OPTIONAL SERVICE BULLETIN NO. OSB 42-075

| Туре: | DA 42 |

Use of Diesel Fuel (EN 590) on DA 42 Aircraft.

Sketch 1:

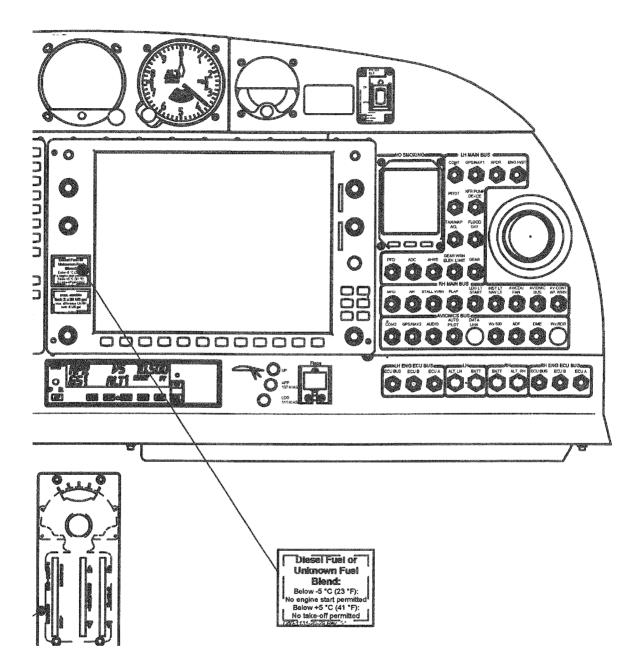
- 2. Incorporate AMM-TR-MÄM-42-037 into the Airplane Maintenance Manual according to instructions given on the cover sheet of the AMM-TR-MÄM-42-037.
- 3. Place Fuel Temp Placard D60-1131-20-29 on Garmin G1000 MFD according to Sketch 1.
- 4. Make all necessary entries in the airplane logs.
